Subject: Babcock & Wilcox Nuclear Energy, Inc. (B&W NE) Response to NRC Request for
Additional Information

Reference: 1. B&W NE Instrument Setpoint Methodology Topical Report 08-002089-001
2. Request for Additional Information Letter No.4 for the Review of Babcock & Wilcox
(B&W) mPower Reactor Project Instrument Setpoint Methodology Topical Report
08-002-2089 [sic] Revision 1

Babcock & Wilcox Nuclear Energy, Inc. Response to
Requests for Additional Information No. 6236
RAI Letter No. 4

B&W mPower Pre-Application Activities
Docket No. PROJ 0776
Topical Report 08-002089-001

Figure 5.1: Setpoint Relationships – For Increasing Setpoint (Similar for decreasing setpoint, but process is decreasing towards the setpoint).

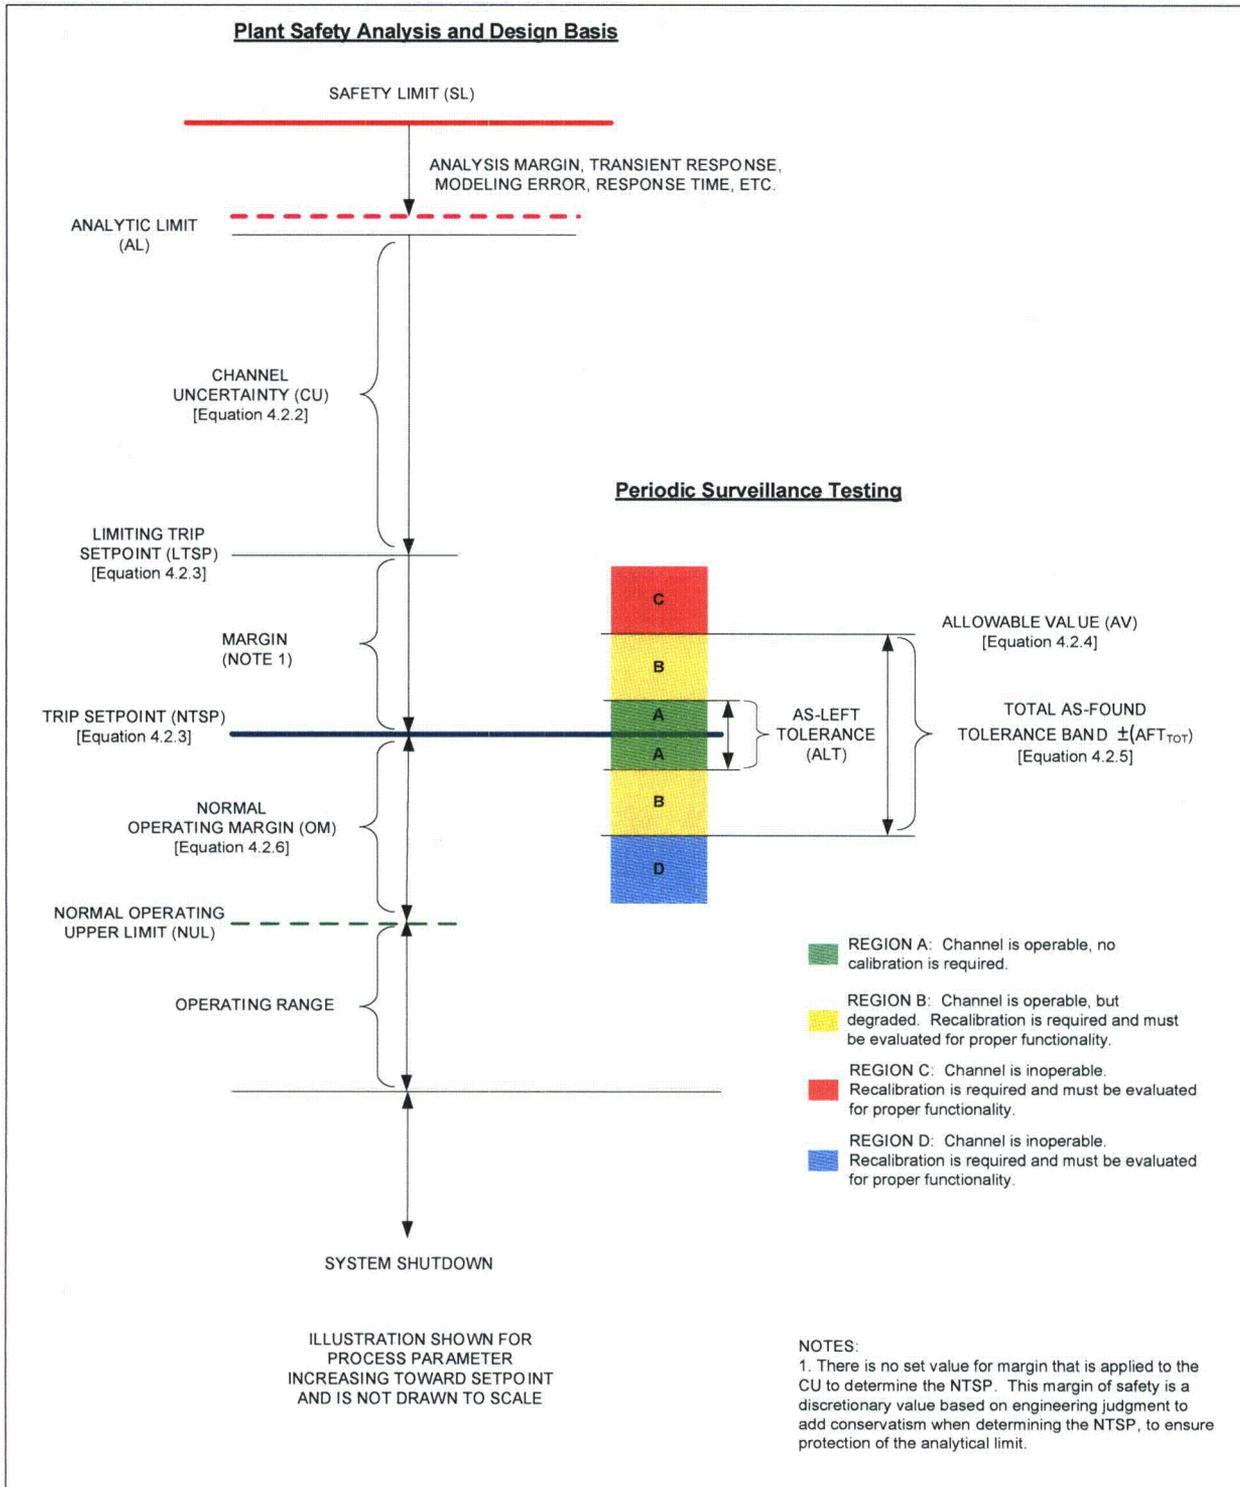
Figure 5.1 - This figure shows Margin (Note 2) added to the setpoint calculation.

The staff requests that the applicant clarify the use of margin in the figure and revise the figure to reflect both the +/- of AFT, ALT, and the location of Margin (Note 2) in relationship to NTSP, AFT and AV (see below).

- Section 4.2.4 - How is AFT^{TOT} calculated as a +/- value and shown on both sides of NTSP on Figure 5.1?
- Section 4.2.5 - How is AFT_n calculated as a +/- value?
- Section 4.2.4 - Explain why the definition of Margin is different from Note 2 on Figure 5.1.
- Is Margin (Note 2) correctly shown on Figure 5.1? see bullet 1 above.
- What value of ALT would be used in Figure 5.1? (Refer to RG 1.105 Rev. 3 Figure 1, "E. Region of Calibration Tolerance")

To clarify the relationship between Margin and NTSP, AFT and AV a number of changes will be made to Figure 5.1 and the text contained in Sections 4.2.4 and 4.2.5 of the topical report.

The as-found tolerance is used, when applied to the NTSP, to determine the allowable value for the instrument channel. The AV is the limiting value of an instrument's as-found trip setting during surveillance testing while still ensuring the AL and SL are protected. If the as-found value for the NTSP is non-conservative with respect to the AV, actions are required to restore the NTSP. Additionally, RIS 2006-17 raised concerns about conditions where the as-found NTSP may be more conservative than the AV, indicating that abnormally large changes in the trip setpoint have occurred which could be signs of the channel malfunctioning. Thus a concept of a double-sided acceptance criteria band for the measured trip setpoint during surveillance testing was introduced.

Figure 5.1 will be updated to properly illustrate the application of a double-sided band for the AFT_{TOT} as applied to the NTSP to ensure consistency with revisions to equation 4.2.4 described above. Additional revisions and enhancements to Figure 5.1 (page 24) include the following and the revised figure is shown below:

- Addition of a double-sided band for the ALT to aid in determination of channel operability and be consistent with Figure 1 in RG. 1.105.
- Illustration of regions of different conditions that may exist during periodic surveillance testing to clarify status of channel operability and required actions (if any).
- Removal of the margin applied to the AFT_{TOT} and its associated note (Note 2). (To protect against the potential for masking of equipment degradation during periodic surveillance testing.)

Figure A.2: Relationships between analytical limit and calculated setpoints

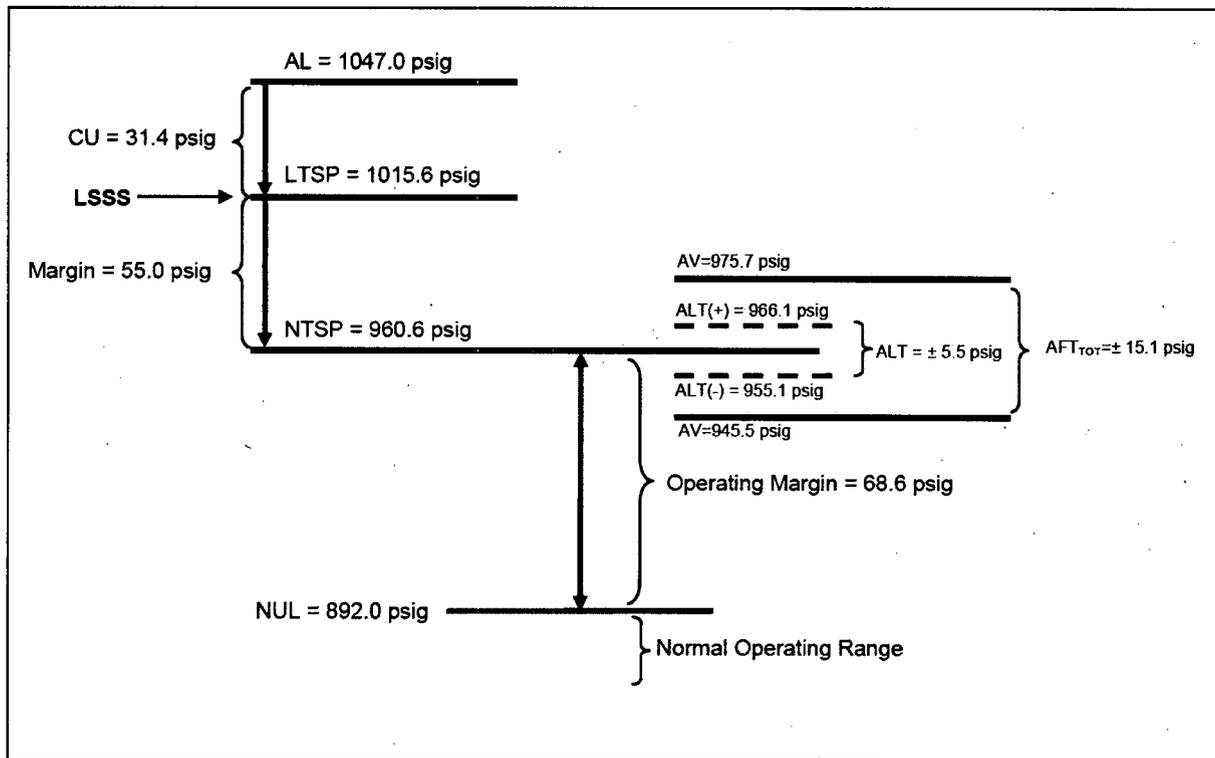
Appendix A Figure A.2 - The staff requests the applicant to respond to the following:

- Is margin correctly shown as 5.5 psig?
- Using example problem and Notes 1& 2 from Figure 5.1, what would AV, Margin 2 and AFT^{TOT} be if Margin 1 is 5.5 psig (allowed by note 1) versus 55 psig?

Appendix A Figure A.2 - The staff requests the applicant to respond to the following:

- Using $AFT^{TOT} \pm 15.1$ psig (-15.1 psig), what would be the operating margin (OM) as described in Section 4.2.6 in order to avoid potential spurious channel trips?
- Is the methodology described in 4.2.6 sufficient for all cases?

Appendix A Figure A.2 contains a typographical error where the margin was incorrectly shown as 5.5 psig. The proper value for the margin as determined in this example is 5.0% of the span which is 55.0 psig.

Based on the revision to Figure 5.1 and section 4.2.4 discussed in response to Question 07.01-C Appendix-9, the relationship between the allowable value, as-found and as-left tolerances is more clearly understood. Figure A.2 has been revised to more clearly illustrate the relationships in the example between the AFT and ALT as shown below:

Additional information was included in the example presented in Appendix A to specify the normal upper limit (NUL) is 892 psig. Therefore, when applying equation 4.2.6 for an increasing process the operating margin (OM) is calculated as follows:

$$OM = NTSP - NUL \text{ (increasing setpoint)} = 960.6 \text{ psig} - 892.0 \text{ psig} = 68.6 \text{ psig}$$
